Product Change Notification

PCN-FDC-9039-2023

Description for Product Change Notification

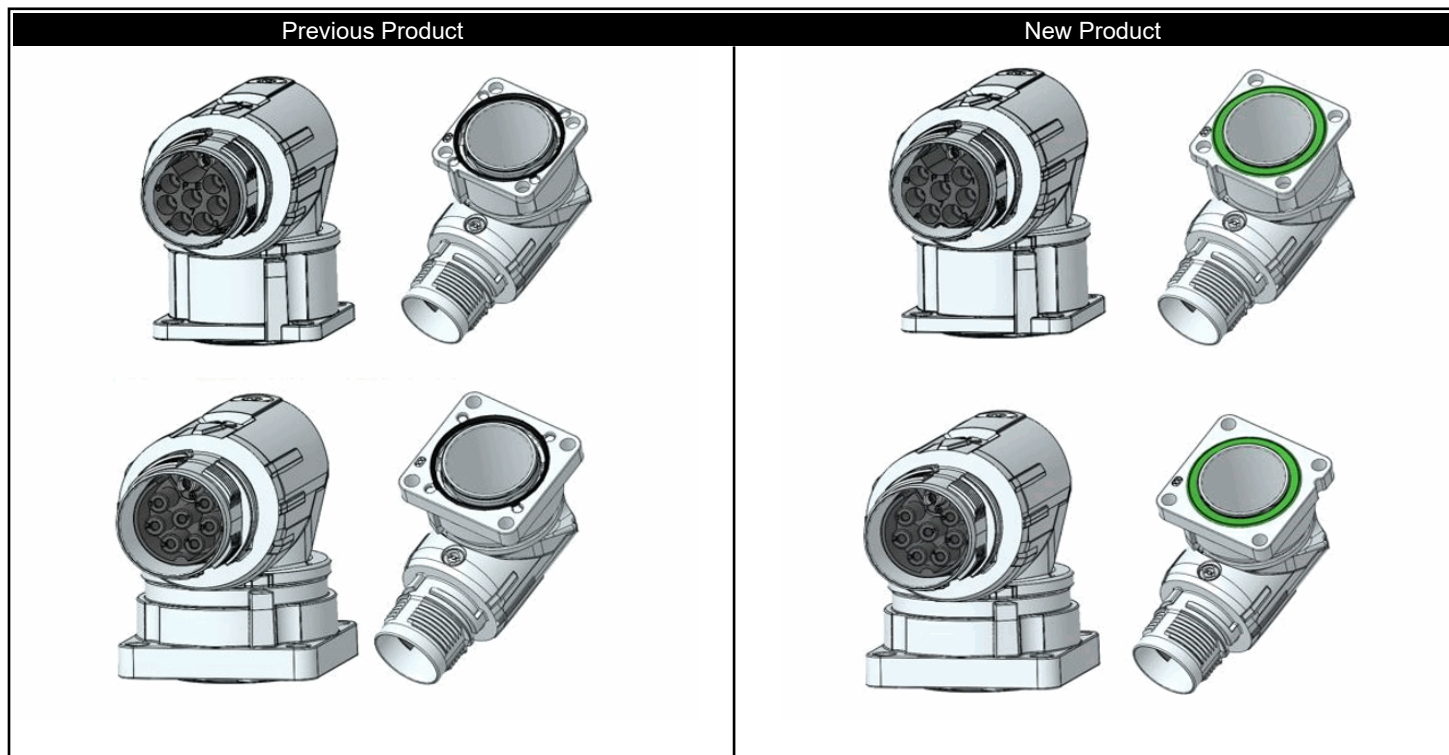
The flanges of the angled, rotatable M17 and M23 PRO series device connectors is being adapted. The sealing groove and outer geometry of the 28 x 28 mm flange are being changed due to increasing demands on process and delivery capability.

In both connector versions, the black O-ring placed in the sealing groove on the underside will be replaced by a green molded seal. This change improves process reliability during production and ensures safety of the base seal during transport.

Additionally, to improve process reliability during assembly, the contour on the outside of the 28 x 28 mm flange will change. See the images attached for more details.
